SCHINDEWOLF GYM ADDITION  
KLEIN INDEPENDENT SCHOOL DISTRICT  
SPRING, TEXAS

39-25107-00  
JANUARY 17, 2025  
ADDENDUM 1

**ADDENDUM 001**

DLR Group Project No. 39-25107-00

**1 COMPOSITE ELECTRICAL LIGHTING PLAN LEVEL 2**  
 1" = 20'-0"

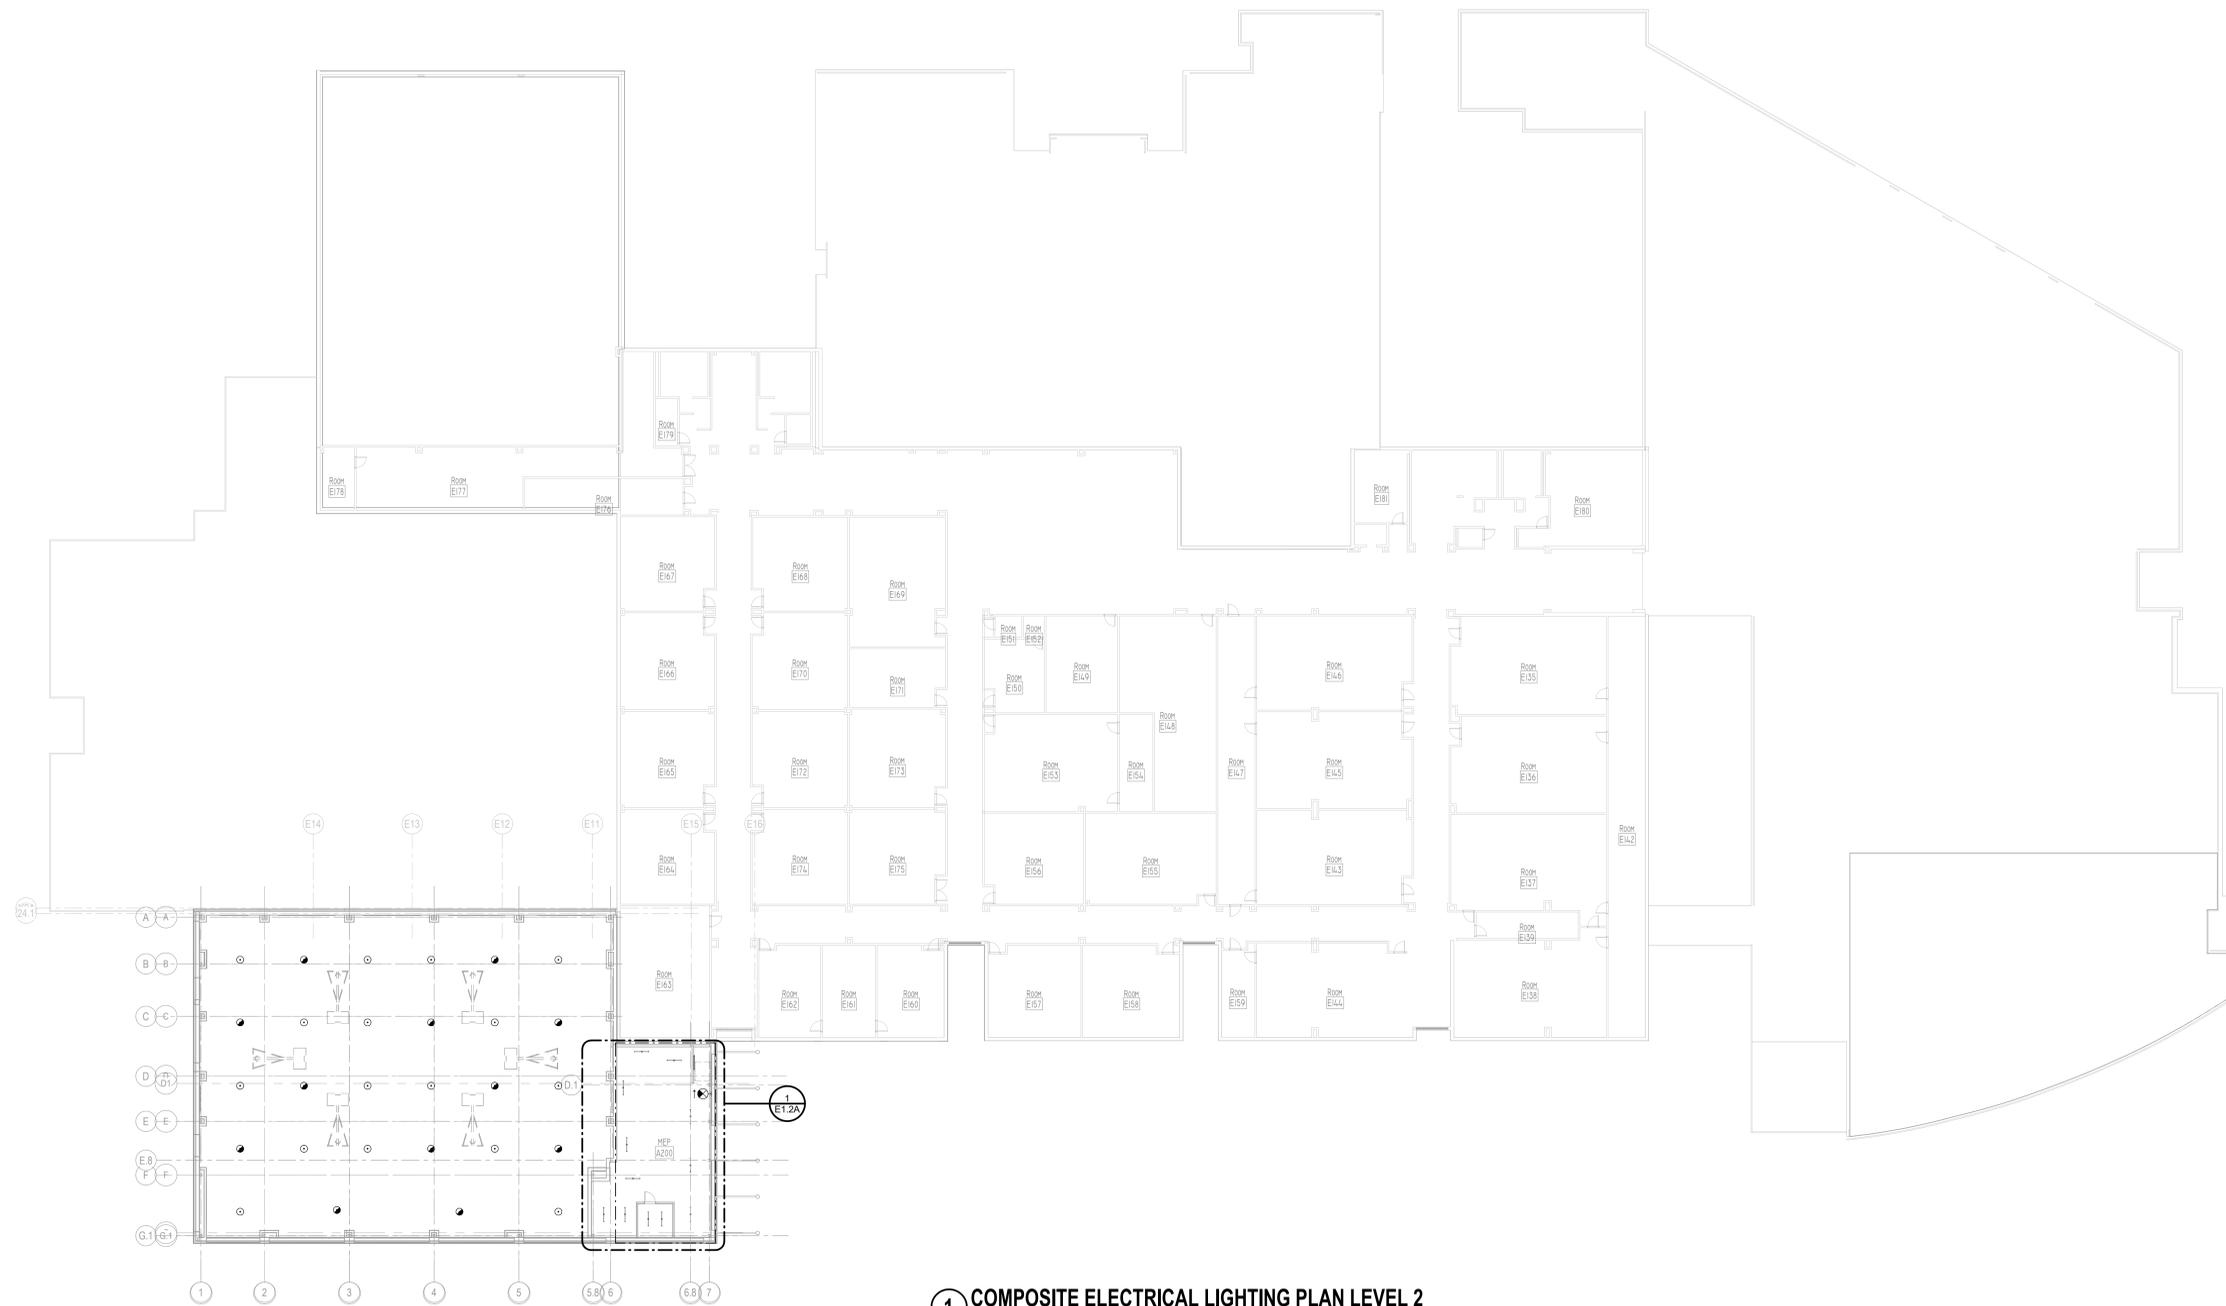
**ITEM NO. 30 -** Sheet E1.2 – COMPOSITE ELECTRICAL LIGHTING PLAN LEVEL 2

- a. Revised true north arrows. See revised sheet.

**1 ELECTRICAL POWER PLAN LEVEL 2 - AREA A**  
1/4" = 1'-0"

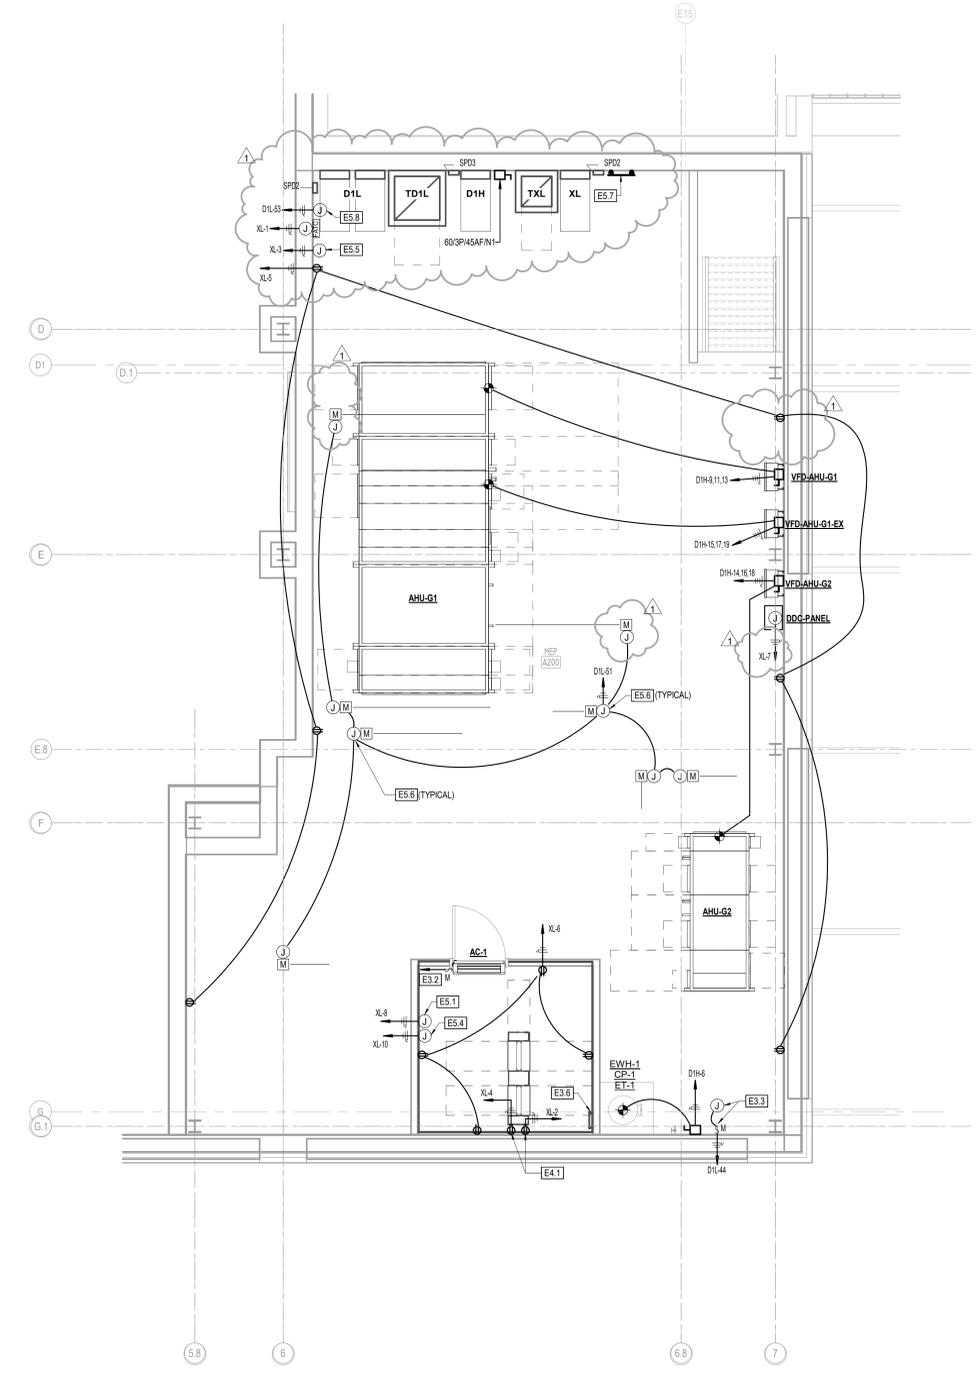
**ITEM NO. 35 -** Sheet E2.2A – ELECTRICAL POWER PLAN LEVEL 2 – AREA A

- a. Revised true north arrows. See revised sheet.
- b. Added new electrical panels. See revised sheet.
- c. Added new SPDs. See revised sheet.
- d. Added new transformers. See revised sheet.
- e. Removed (1) VFD and circuit. See revised sheet.
- f. Modified electrical keyed notes. See revised sheet.

**2 ELECTRICAL POWER PLAN LEVEL 1 - NEW CHILLER**  
1/4" = 1'-0"

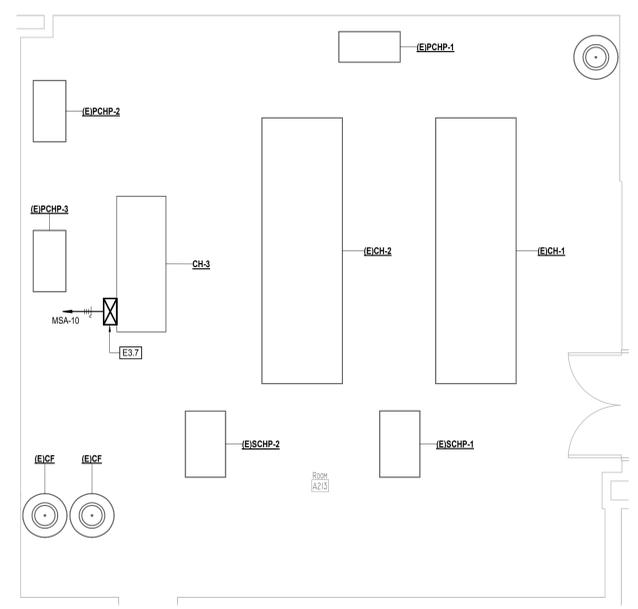
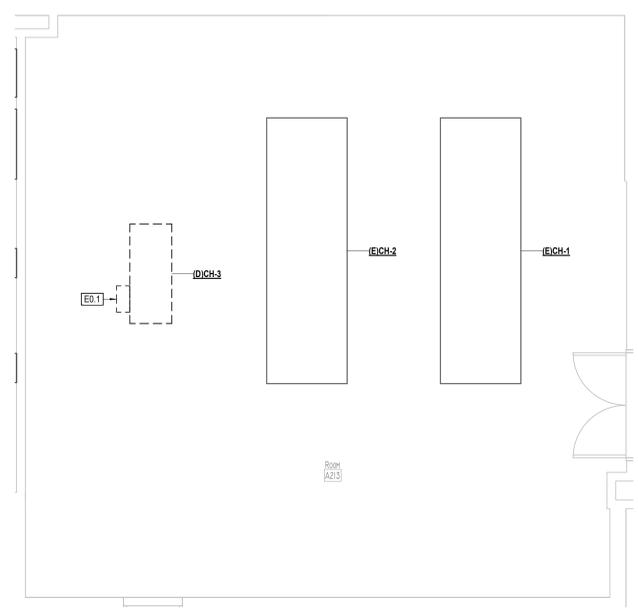
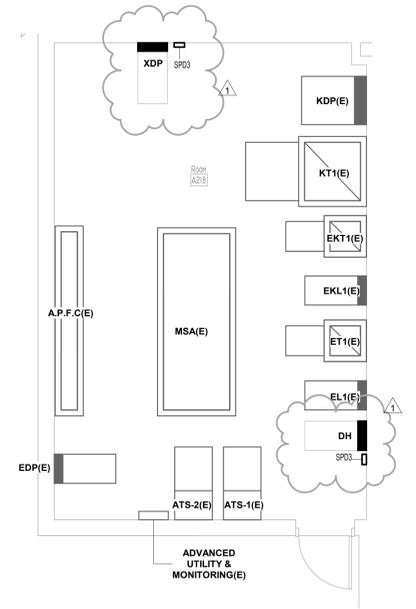
**ITEM NO. 36 -** Sheet E3.1 – ENLARGED ELECTRICAL POWER PLANS – DEMO & NEW

- a. Revised true north arrows. See revised sheet.
- b. Added electrical panels. See revised sheet.

- c. Added SPDs. See revised sheet.
